UNITED STATES PATENT AND TRADEMARK OFFICE

Office Action Summary	Application No. 10/718,086	Applicant(s) CLEMENS, READE	
	Examiner PHONG H. NGUYEN	Art Unit 3724

DETAILED ACTION

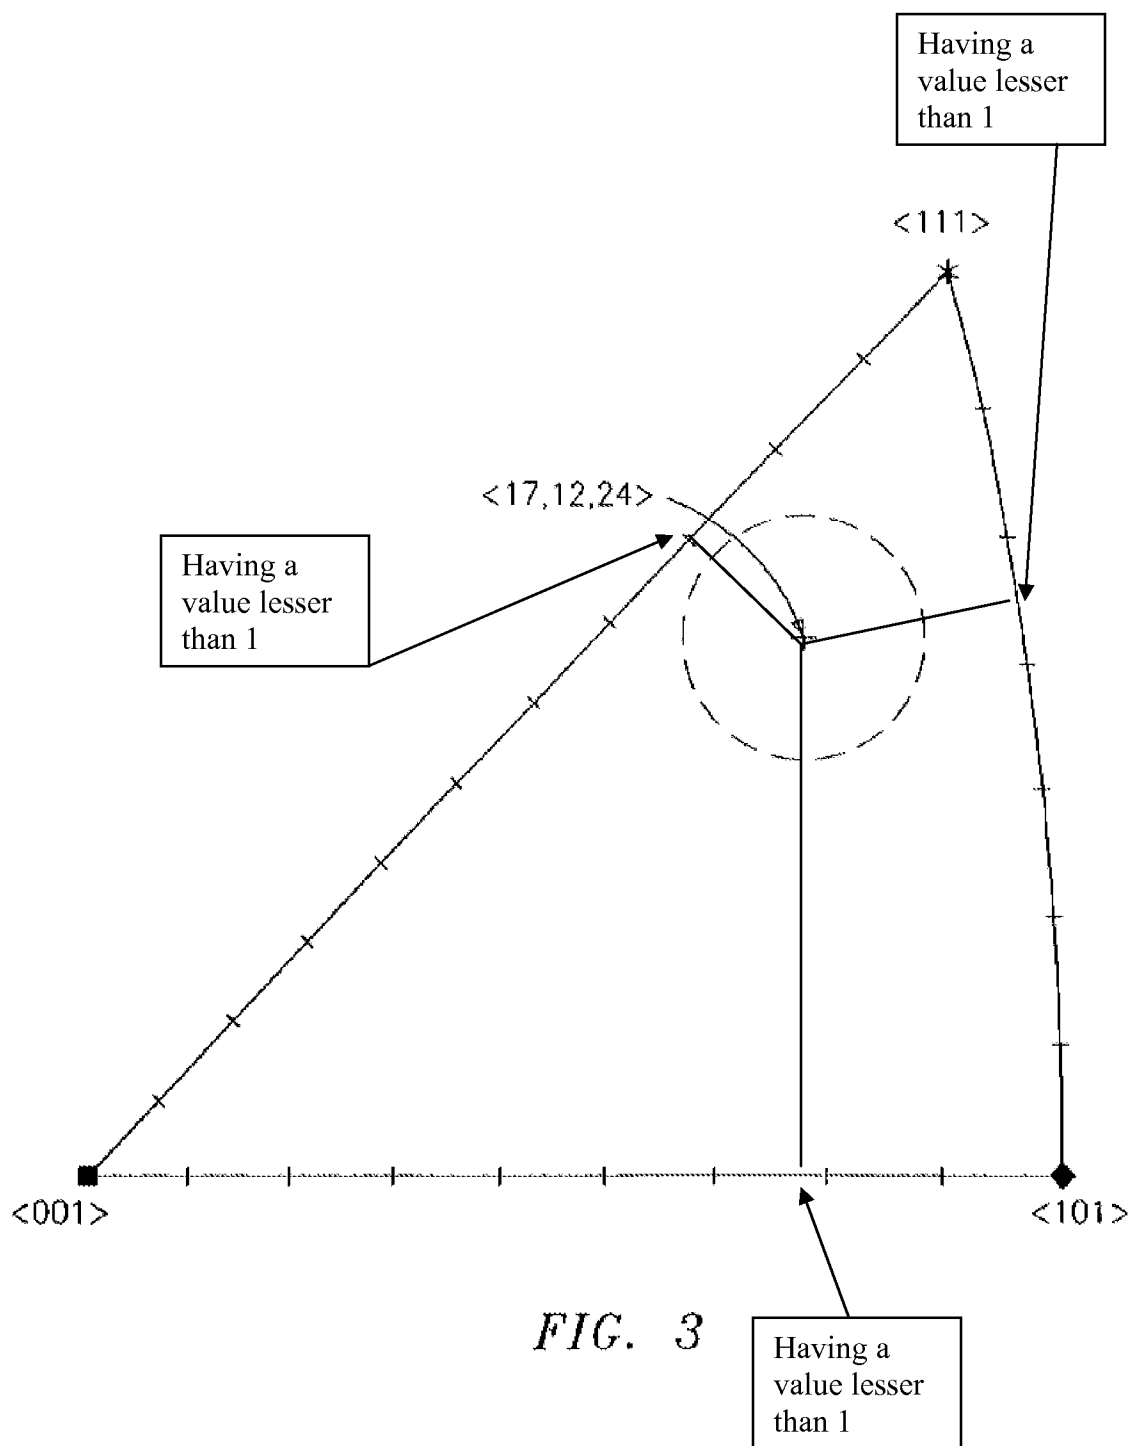
Regarding paragraph 11 of the Declaration, it is well known in crystallography that the values in the bracket indicate the coordinate of a point in x-y-z directions as asserted by the Applicant. However, it is not the case in the Applicant's Fig. 3 and Specification. The values in x-y-z directions of the diamond tip are lesser than 1 as shown in Fig. 3 since the maximum values in x-y-z directions are 1. Therefore, it is unclear how the diamond tip can have the value of x=17, y=12, and z=24.

Furthermore, the Applicant has not explained the meaning of the term “within 8 degrees of a <17, 12, 24> direction”. If the “variants” mean the “degrees” in claims 1, 13 and 14, what are the eight claimed variants?
